**CASE NO. 2020-00190**  
**HORSESHOE BEND SOLAR, LLC**  
**RESPONSES TO SITING BOARD'S SECOND REQUEST FOR INFORMATION**

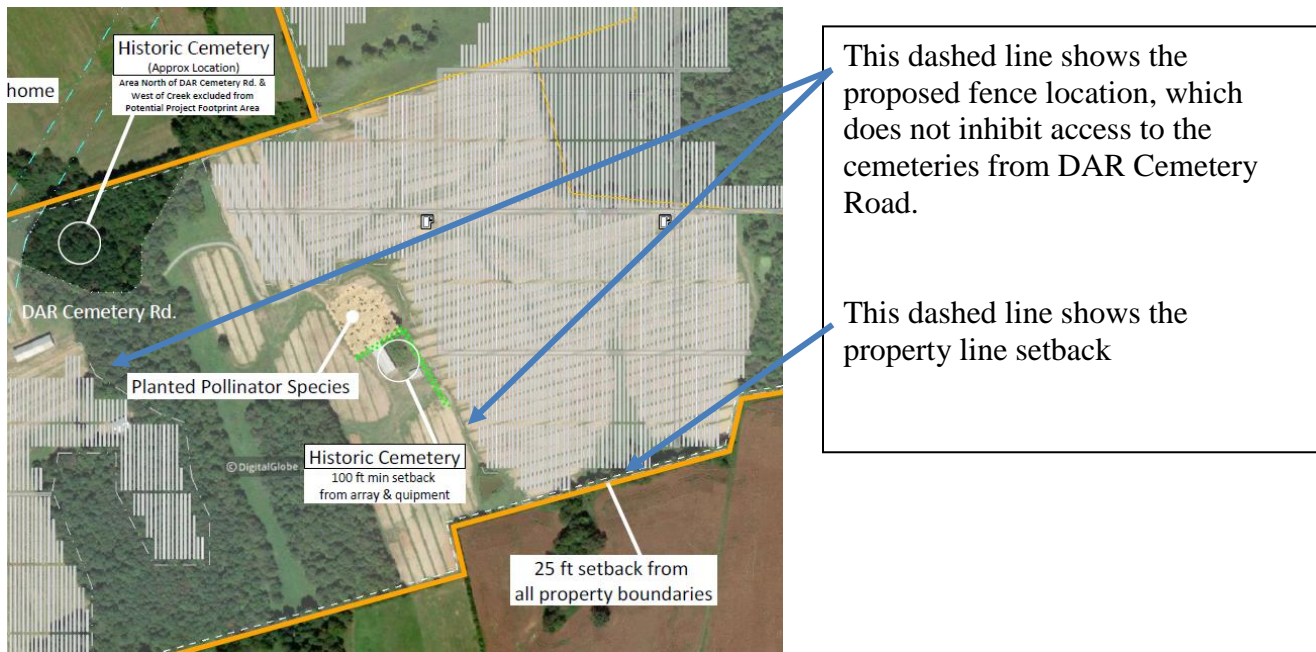
**2. Refer to the Supplement to Section 6 of the Site Assessment Report related to mitigation measures. Explain whether decommissioning includes subsurface structures such as foundation piles for the racking systems. Describe any subsurface structures that might remain after decommissioning is completed.**

RESPONSE: Horseshoe Bend's proposed mitigation measure related to decommissioning, from our supplemental mitigation measures filing, is copied below, and includes the removal of subsurface structures such as concrete pads and trenched electrical wiring. There will not be any subsurface structures that will remain after decommissioning is completed.

Solar racking systems are typically pounded into the ground with pile drivers, and without the use of concrete foundations. Very limited amounts of concrete are typically installed at site as pad mounts for central inverters and energy storage systems, if used. The racking piles are removed by pulling them out of the earth, so that nothing remains in the ground.

Horseshoe Bend, its successors or assigns, shall decommission the entire site if the Project ceases producing electricity for a period of more than twelve (12) months. Decommissioning shall involve the removal of all solar panels, racking, and equipment including concrete pads and trenched electrical wiring. Fencing and internal access roads shall also be removed, unless the landowner states in writing that they prefer fencing and internal roads to remain in place. This mitigation requirement shall be deferred if Horseshoe Bend continues with its currently proposed operation beyond 40 years.
